ATTENTION TURN-TIKE OWNERS

VENTURE RIDE MFG. GREER, S.C.			
DRAWN	DATE	SCALE	REQ'D PART NUMBER
BHW	3-24-76		VRM-9036

S A F E T Y    B U L L E T I N

RESISTOR ILLUSTRATION

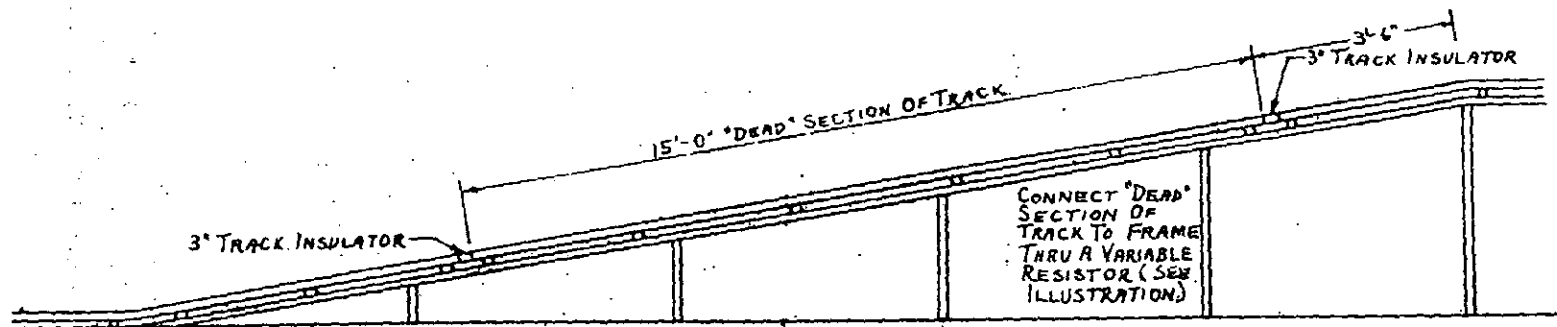
TO GET BETTER CONTROL OVER THE TURN-TIKE CARS GOING DOWN THE RAMP, WE RECOMMEND.

- 1) INCREASING THE LENGTH OF THE "DEAD" SECTION OF TRACK TO 15 FT.
- 2) CONNECTING THE "DEAD" SECTION OF TRACK TO THE TRAILER FRAME OR TRACK SUPPORT POST THRU A VARIABLE RESISTOR.
